Appl. No. 09/978,409
Amdt. Dated September 17, 2004
Reply to Office Action of April 19, 2004

Amendments to the Drawings

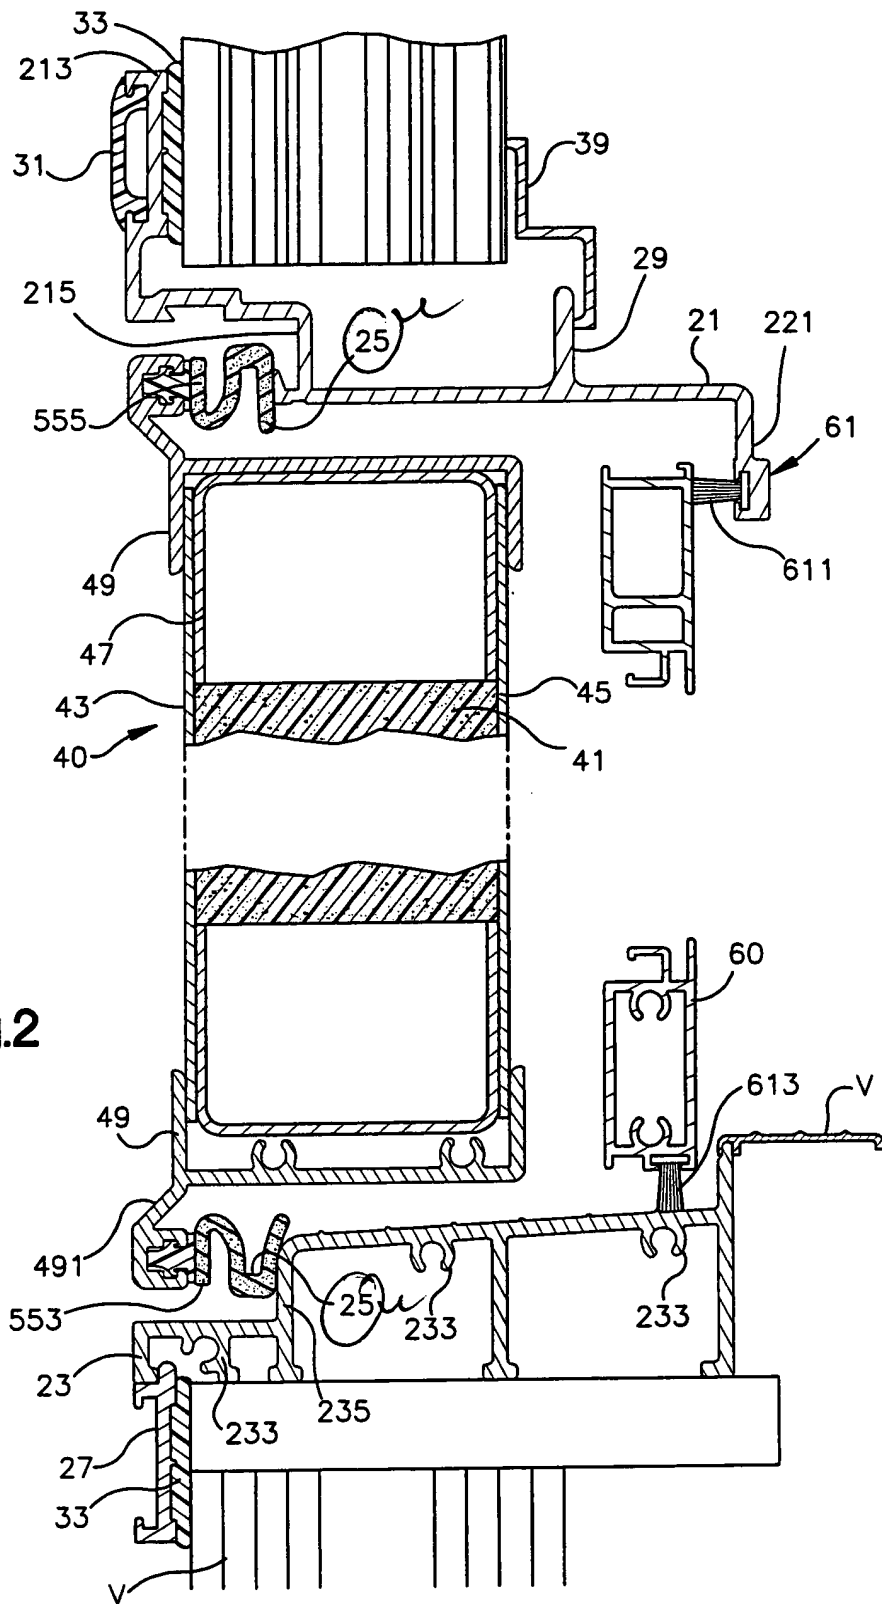
The drawings stand objected to, because reference numeral 25 in Figure 2 is assertedly not as described on page 7. The reference to element 25 has been removed, and the two instances of numeral 25 on Figure 2 have been deleted, as reflected in the above amendment. Also, it is asserted that element 855 is used for two different elements in Figures 4 and 7. Numeral 855 is corrected to numeral 856 in Figure 7 and in reference to Figure 7 on page 9, as reflected in the above amendment.

The attached sheets of drawings include changes to Figures 2 and 7. The first replacement sheet, which includes Figure 2, replaces the original sheet including Figure 2. Figure 2 has been amended to delete two instances of reference numeral 25. The second replacement sheet includes Figures 7, 8A, and 8B and corrects numeral 855 in Figure 7 to numeral 856.
